- NO EXCEPTION TAKEN
- REJECTED
- MAKE CORRECTIONS NOTED
- REVISE AND RESUBMIT
- SUBMIT SPECIFIED ITEM

A	04/20/12	RC	FOR APPROVAL
NO.	DATE	BY	REVISION
STS STEEL, INC. ENGINEERS • FABRICATORS • ERECTORS PH: (518) 370-2693 FAX: (518) 370-2696			
DRAWING TITLE UPPER STEEL (U7-U8 & U10-U11)			
PROJECT No. US RT 2 BRIDGE No 24 FEDERAL AID No.			
ENGINEER : CHA			
CUSTOMER : Harrison & Burrowes Bridge Constructors, Inc.			
PROJECT : RICHMOND, VT - TRUSS BRIDGE REHAB			
RICHMOND, VT			
HOLES:	15/16" U.N.O.	PAIN:	PER SPEC
BOLTS:	A325 U.N.O.	DRBY:	RC
WELDS:	AWS D1.5	CHKBY:	SG
		DATE:	03/16/12
		JOB NO.:	1156
		DWG NO.:	47

ONE REQ'D ~ Mk. M47B

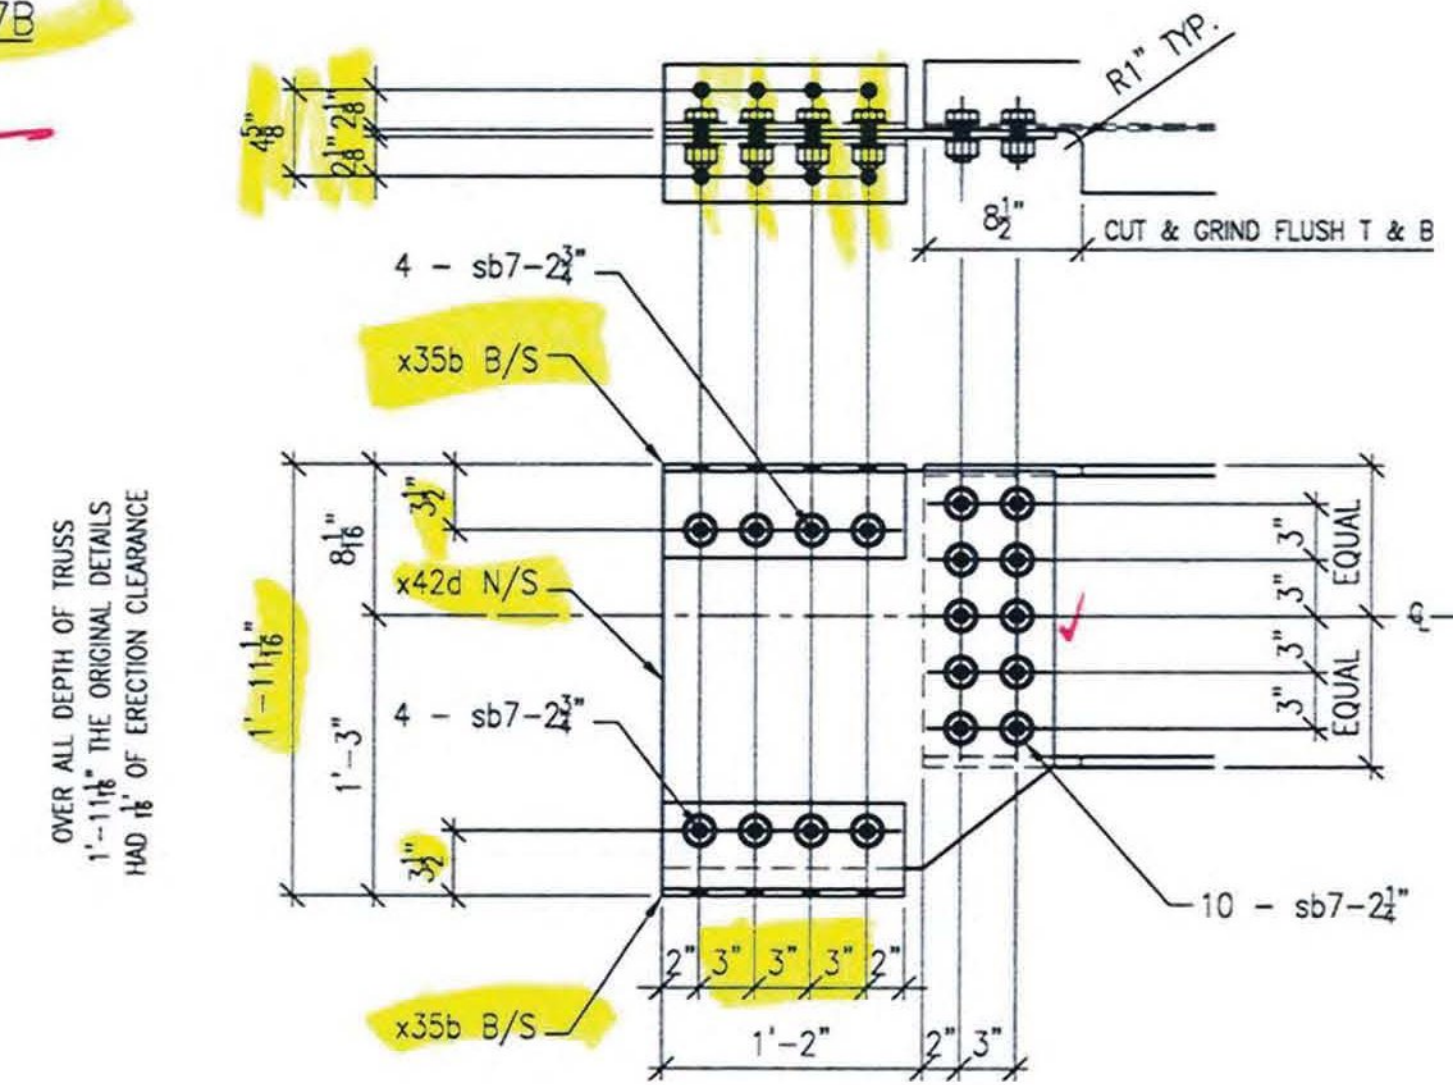
OVER ALL DEPTH OF TRUSS
1'-1 1/4"
HAD 1/8" OF ERECTION CLEARANCE
